Project	<b>IEEE 802.16 Broadband Wireless Access Working Group</b> < <a href="http://ieee802.org/16">http://ieee802.org/16</a> >	
Title	An Efficient AMC Zone Configuration within H-ARQ for MIMO OFDMA	
Date Submitted	<b>2004-11-14</b>	
Source(s)	Wonil Roh, JeongTae Oh, Geunhwi Lim, Chan-Byoung Chae, Kyunbyoung Ko, Hongsil Jeong, Sung-Ryul Yun, Seungjoo Maeng, Jaeho Jeon, Jaeyeol Kim, Soonyoung Yoon	<a href="mailto:wonil.roh@samsung.com">wonil.roh@samsung.com</a> Voice: +82-31-279-3868
	<b>Samsung Electronics Co., Ltd.</b>	
	Young-Ho Jung, Seung Hoon Nam , Jaehak Chung, Yungsoo Kim, Sung-Jin Kim, Hojin Kim	
	<b>Samsung Advanced Institute of Technology</b>	
Re:		
Abstract	An Efficient AMC Zone Configuration within H-ARQ for MIMO OFDMA	
Purpose	Adoption of proposed changes into P802.16e	
	<del>Crossed-out indicates deleted text</del> , <u>underlined blue indicates new text change to the Standard</u>	
Notice	This document has been prepared to assist IEEE 802.16. It is offered as a basis for discussion and is not binding on the contributing individual(s) or organization(s). The material in this document is subject to change in form and content after further study. The contributor(s) rese

**Figure 23a An Example of Time Domain Zoning for Multiple Zones in AMC Region of DL H-ARQ MAP (Method 1)**

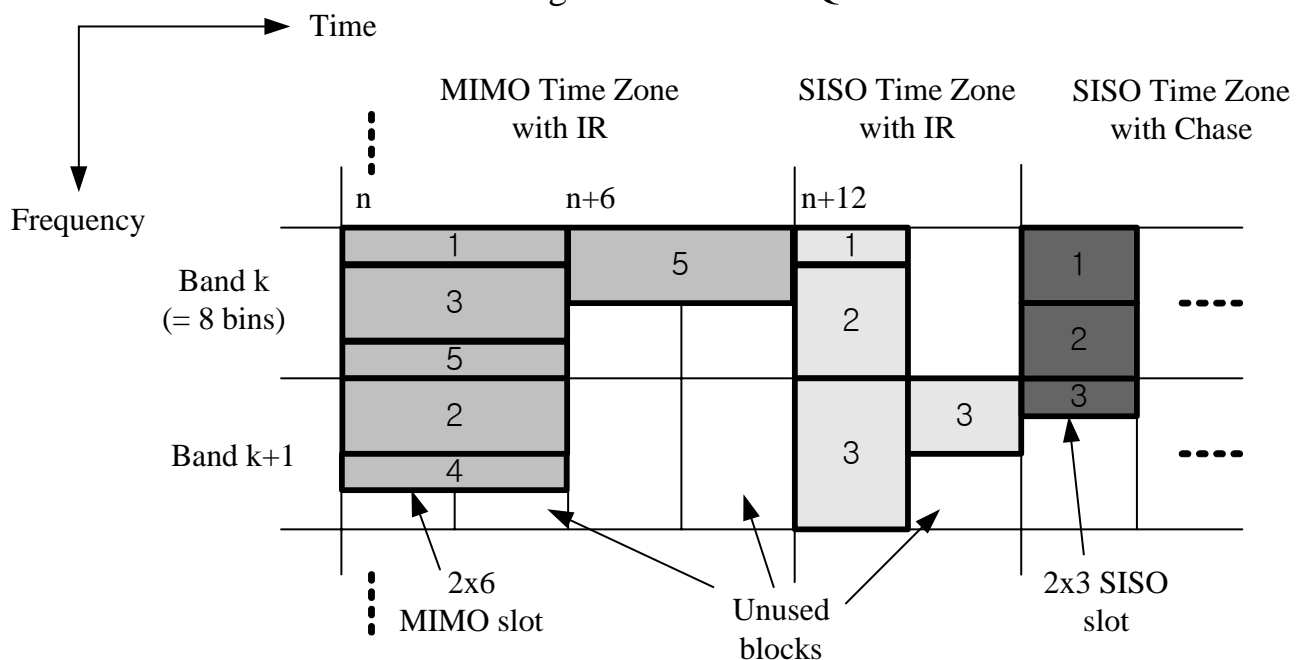
Figure 23a and Figure 23b represent two methods of MIMO zone allocation within AMC band region, time zone allocation in Figure 23a and frequency band allocation in Figure 23b. Each scheme has its own pros and cons. The time zone allocation method has better channel estimation performance due to continuous pilot subcarriers along the entire frequency domain, improving decoder performance and frequency scanning for better choice of an AMC band. On the other hand, frequency band allocation method reduces overhead which otherwise is inevitable at symbol boundaries of different zones. Furthermore, in terms of granularity this method is better because a MIMO or SISO zone can be allocated to one or more bands of the total available bands (12 for the case of 1K FFT and 8 bins per band configuration), whereas 3 (for SISO) and 6 (for MIMO) symbols are the basic unit to be allocated within the available DL sub-frame (24 symbols for the case of 1K FFT with 2:1 DL:UL ratio).

As is suggested in Table 99c, there are two possible AMC zone types. In Figure 23a, the multiple zones are separated in time domain, whereas they are separated in frequency domain in Figure 23b. For the illustration purpose, 1K FFT size with 8 bins per band(12 AMC bands overall) and the 2x3 (2 bins by 3 symbols) basic AMC type are shown in both Figures.

*[Add a new section 6.3.2.3.43.6.9 as follows]*

### 6.3.2.3.43.6.9 H-ARQ Compact DL-MAP IE format for AMC Zone Configuration

Due to the availability of multiple antennas and subpacket combining algorithm, there may be multiple zones in a single frame. When multiple zones exist within the band AMC region of a DL H-ARQ subframe, the adequate zone configuration shall be chosen by the BS and indicated through H-ARQ Compact DL-MAP IE for AMC Zone Configuration (Table 99c).
